RE: **3-DR-2022**  
Western Technologies Addition  
**D6772 (Key Code)**

The Planning & Development Services Division has completed the review of the above referenced development application. The following **1<sup>st</sup> Review Comments** represent the review performed by our team and is intended to provide you with guidance for compliance with city codes, policies, and guidelines related to this application.

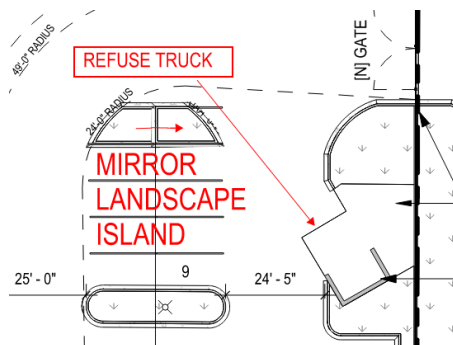
6. DSPM 2-1.309: Mirror northern landscape island to facilitate a 40' long refuse truck at 45' turning radius into refuse enclosure as follows:
